# COMMUNITY DEVELOPMENT DEPARTMENT REPORT

HEARING DATE: 5/6/2025

APPLICANT: Rodney Evans + Partners, LLC

SUBJECT: [H-2024-0059](#)  
Latitude Forty Three Subdivision – AZ,  
PP

## E. Common Driveway Exhibit

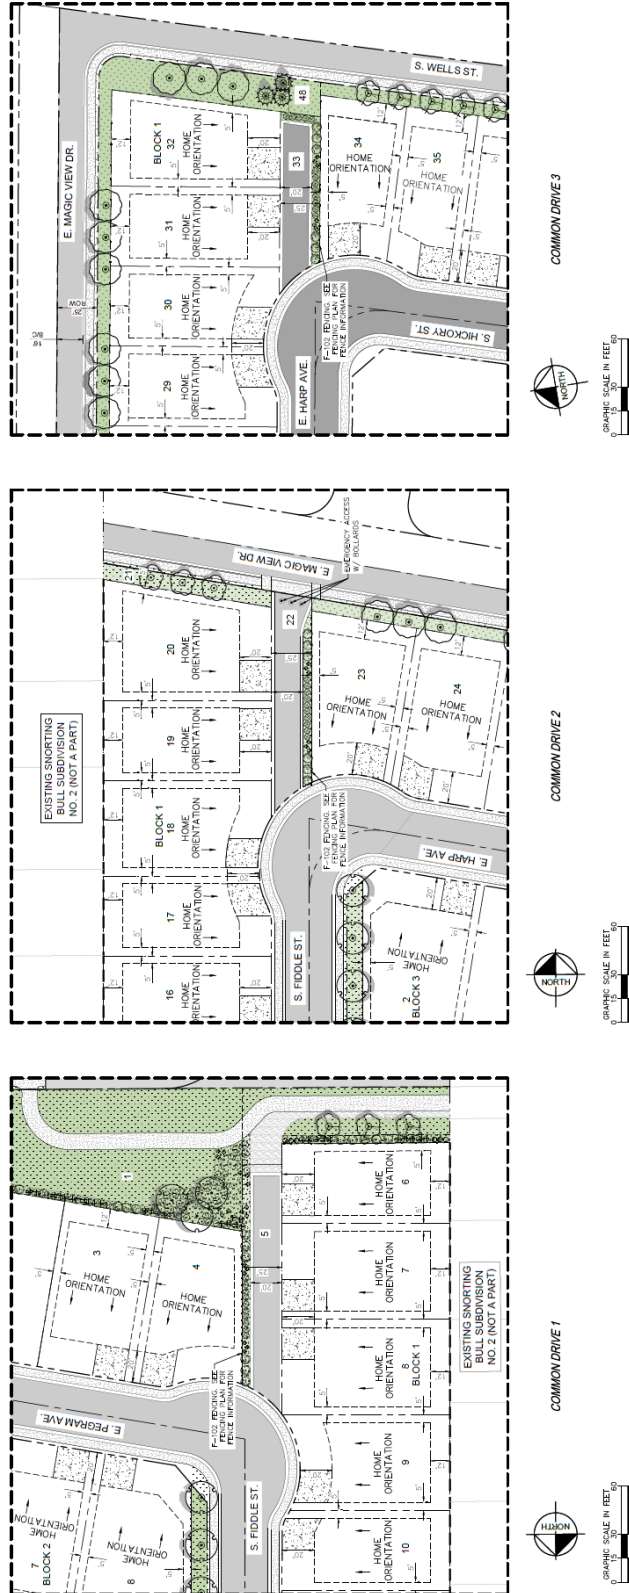
**Common driveways:** Three (3) common driveways are proposed, which are required to comply with the standards listed in UDC 11-6C-3D. Common driveways should be paved with a surface with the capability of supporting fire vehicles and equipment. A common driveway exhibit is included in Section VII.E below that depicts the setbacks, building envelope and orientation of the lots and structures.

- xiv. Remove the sidewalk along the west side of S. Longitude Dr. and provide right-of-way to the west property line.
4. The common driveways shall be constructed in accord with the standards listed in UDC 11-6C-3D and building setbacks shall be as shown on the common driveway exhibit in Section VII.E.

**FENCE SCHEDULE**

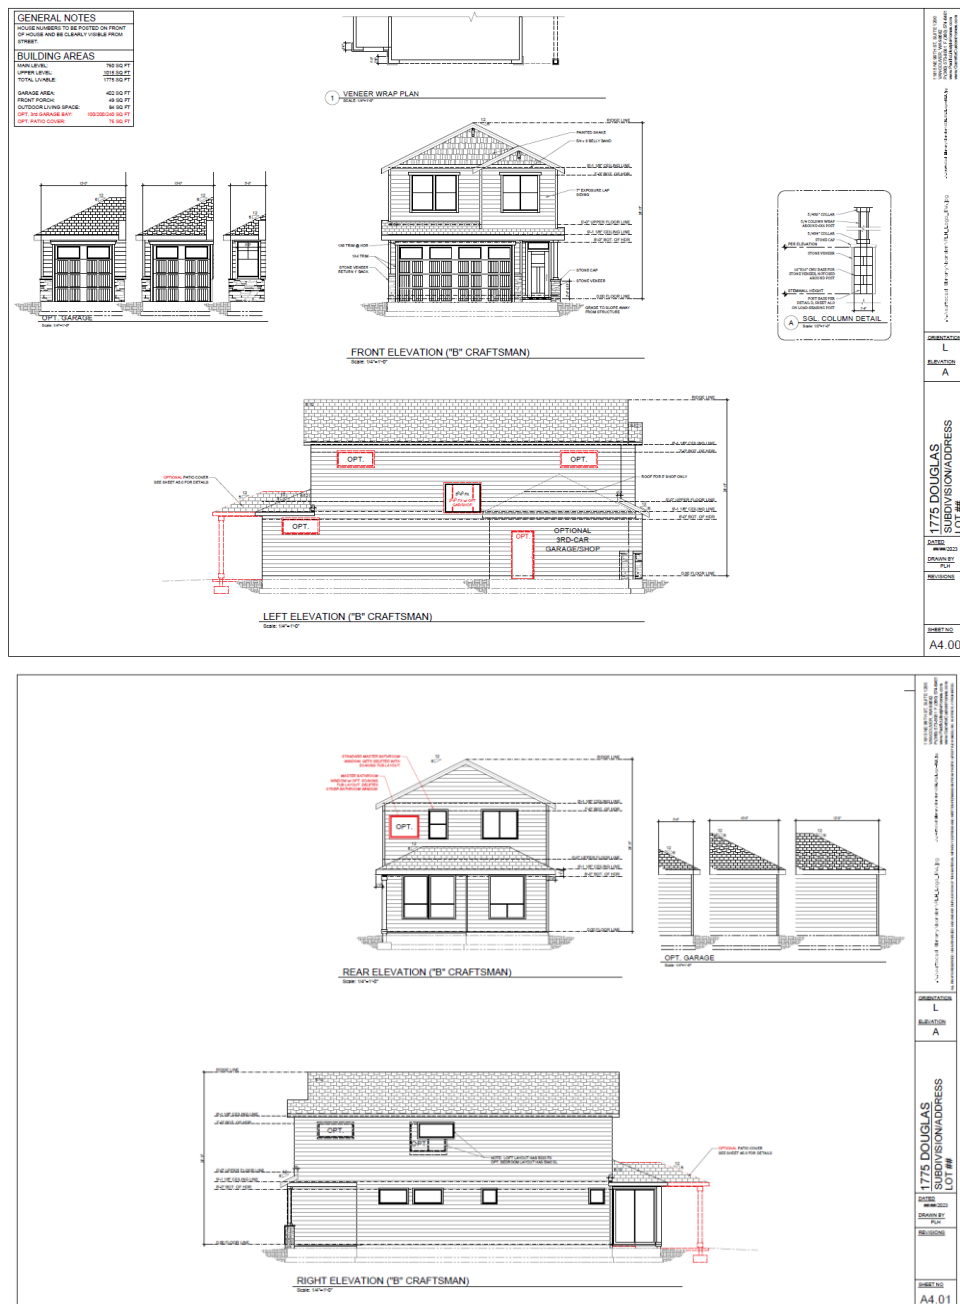
**Fencing depicted along S. Hickory St. on Lots 6 and 7, Block 3 and Lots 5 and 6, Block 2 and along E. Magic View Dr. and S. Wells St. is required to be setback a minimum of 10’ from the street side property line per UDC 11-3A-7C.3. The maximum fence height in the required front yard including the front and side yard property lines shall be 3-feet for a closed vision**

fence and 4-feet for an open vision fence per UDC 11-3A-7C.2. The fencing plan and landscape plan should be revised accordingly to comply with UDC standards.

- vii. The maximum fence height in the required front yard including the front and side yard property lines shall be 3-feet for a closed vision fence and 4-feet for an open vision fence per UDC 11-3A-7C.2; revise accordingly.

- vi. Fencing along S. Hickory St. on Lots 5 and 6, Block 2 and Lots 6 and 7, Block 3 shall be depicted a minimum of 10-feet from the street side property line per UDC 11-3A-7C.3.
